SUBJECT: PRESENTATION MATERIALS FROM THE FEBRUARY 22, 1994 MEETING ON
AP600 DESIGN CHANGES

PRESENTATION
TO
UNITED STATES
NUCLEAR REGULATORY COMMISSION

AP600 Design Changes

MONROEVILLE, PA
FEBRUARY 22, 1994

DEDVI Break, Upper Plenum Pressure

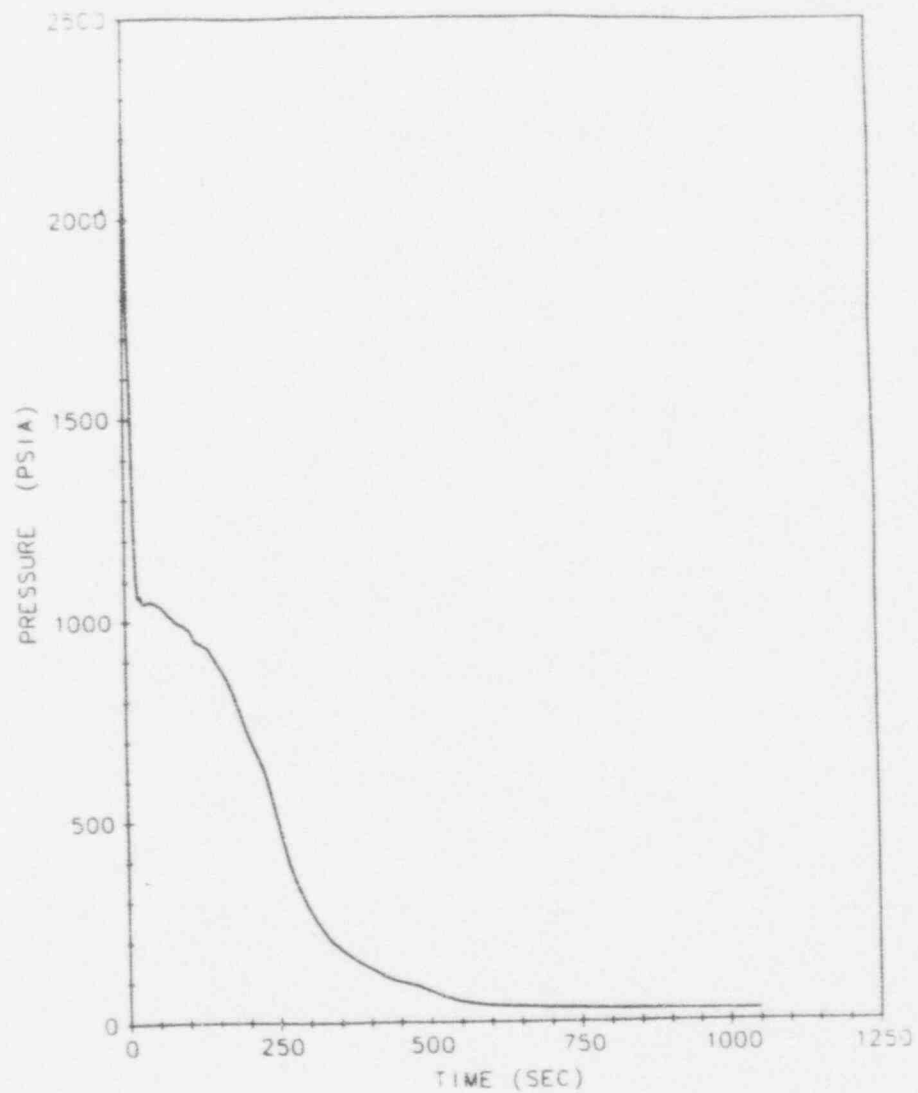
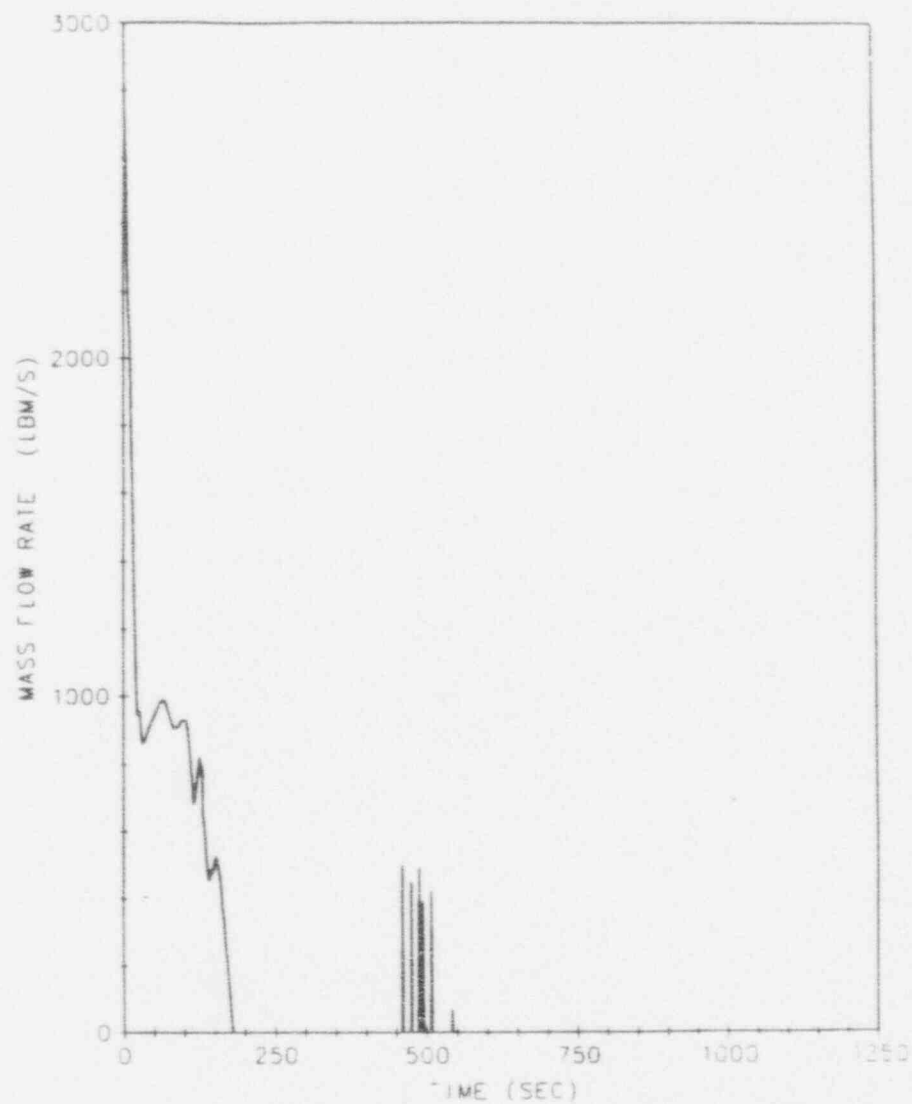
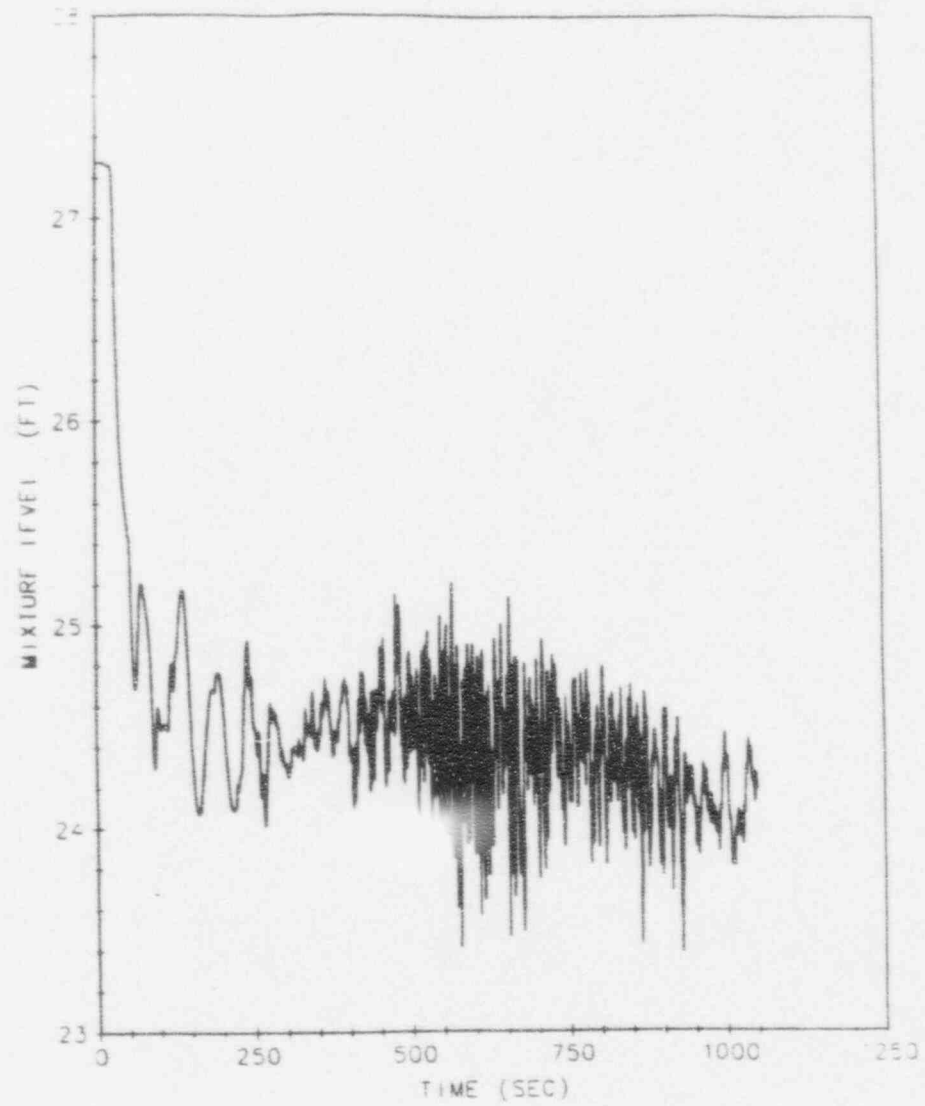
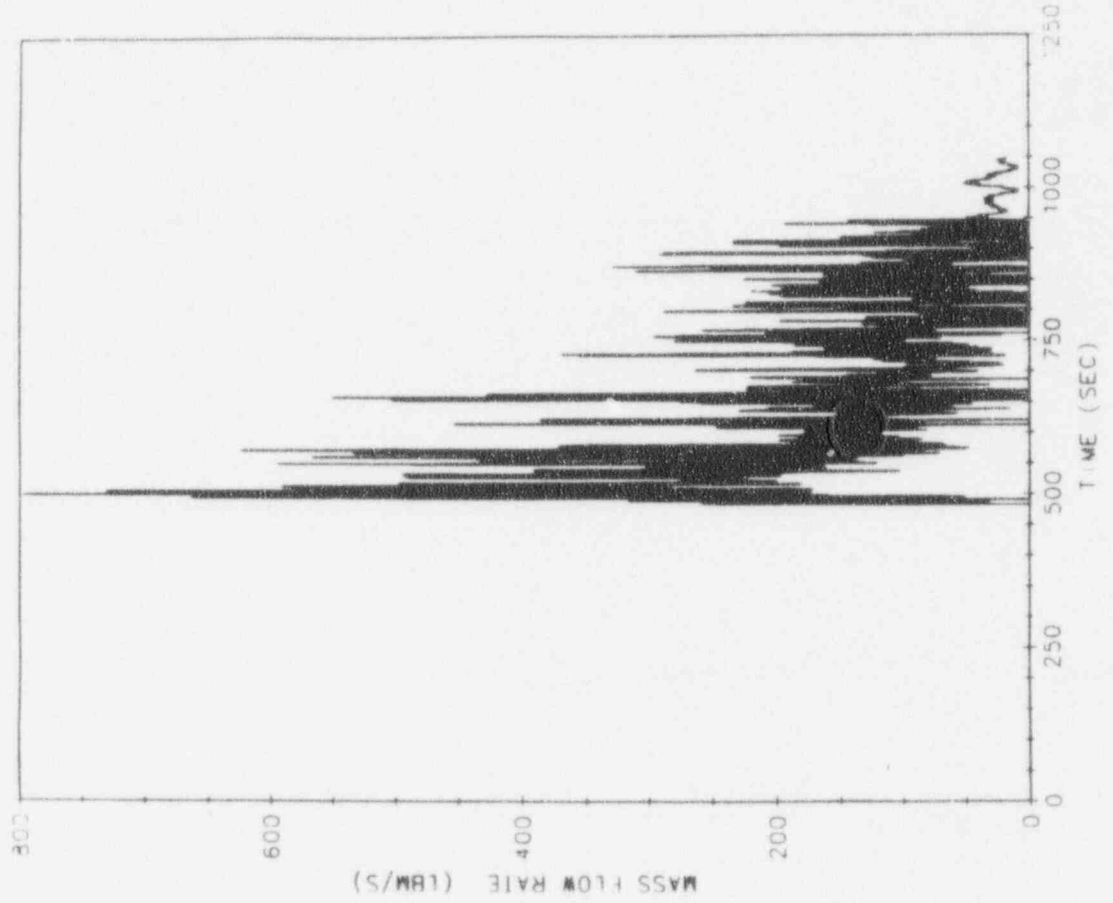
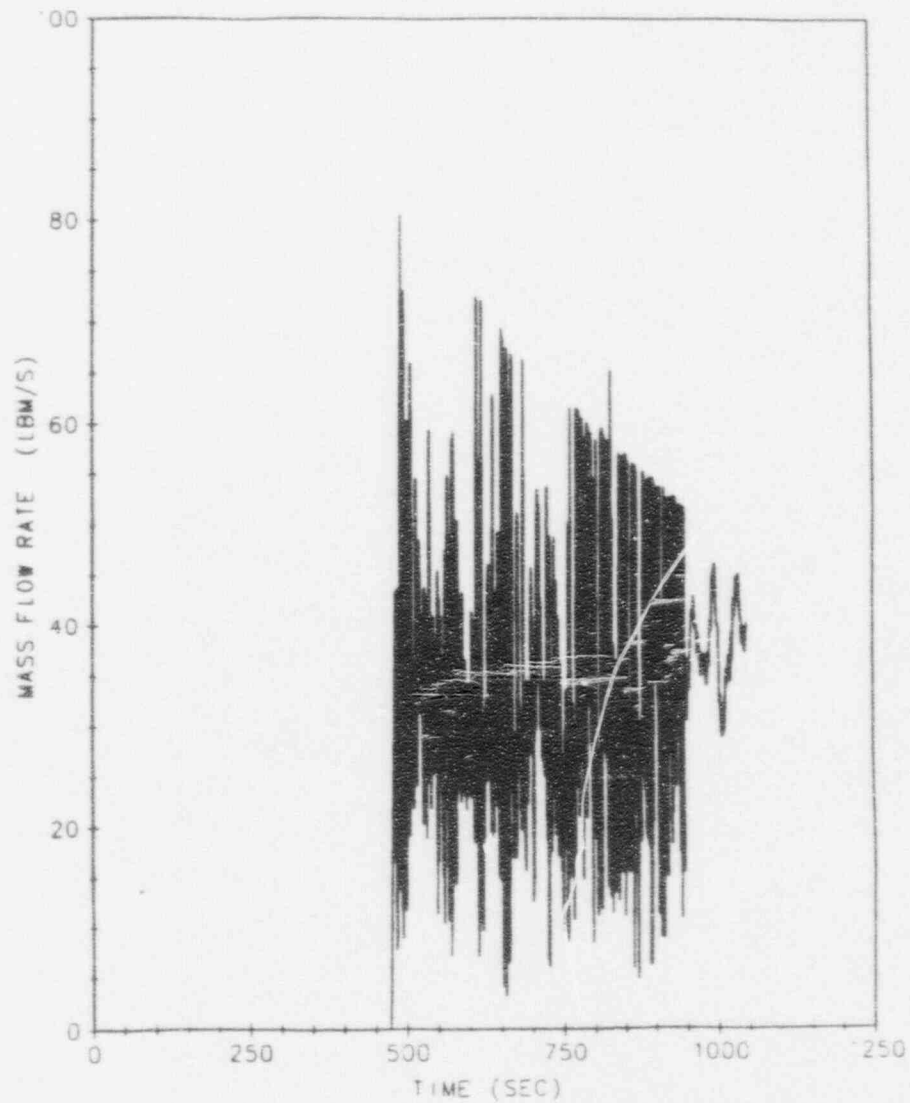
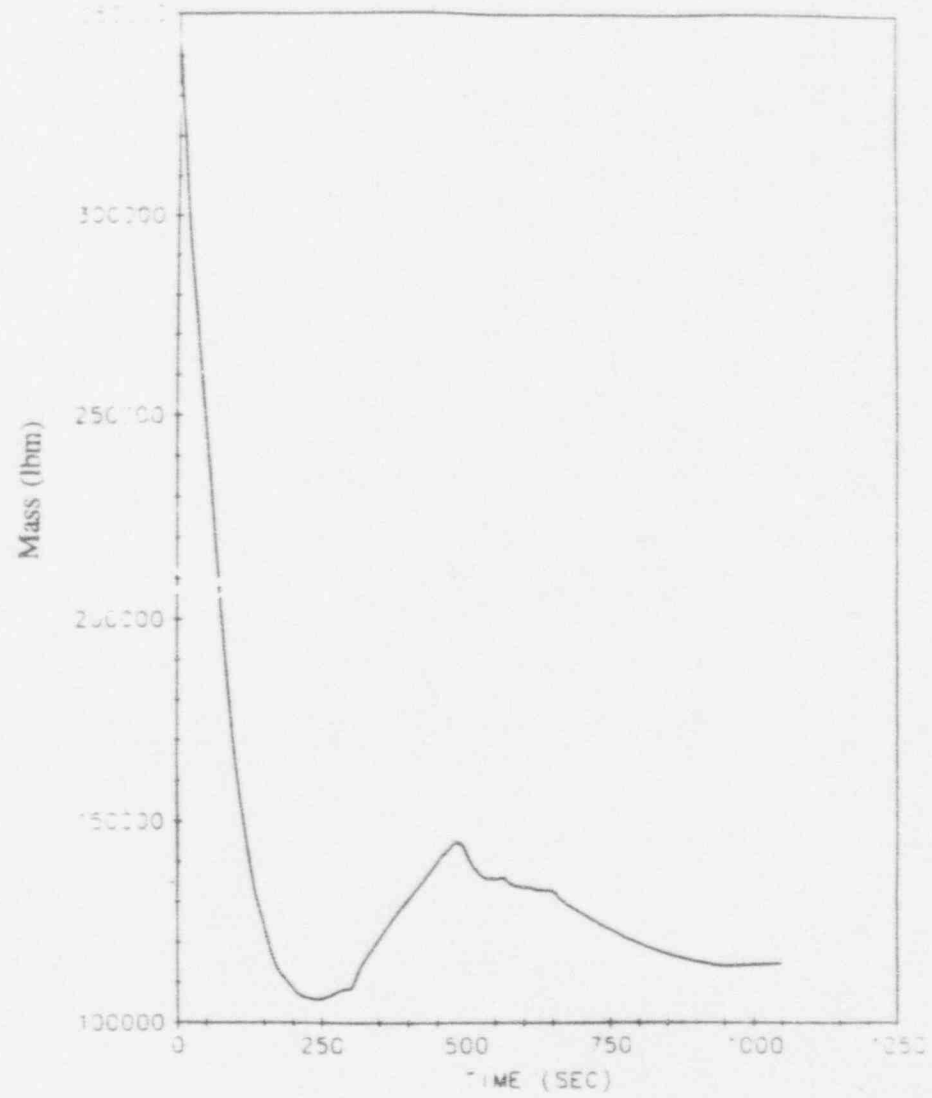
- **The Limiting Small Break LOCA SSAR Cases were Analyzed with NOTRUMP Modeling the Design Changes**
- **DEDVI break for minimum safety injection availability**
 - **Inadvertent ADS actuation for test of ADS venting capability**
- **No Active Systems Modeled**
- **Single Active Failure Assumed Exacerbates Limiting Phenomena**
 - **A first/third stage ADS valve combination for the DEDVI case**
 - **One fourth stage ADS valve for the inadvertent ADS case**
- **Appendix K Evaluation Model Approach as in SSAR**
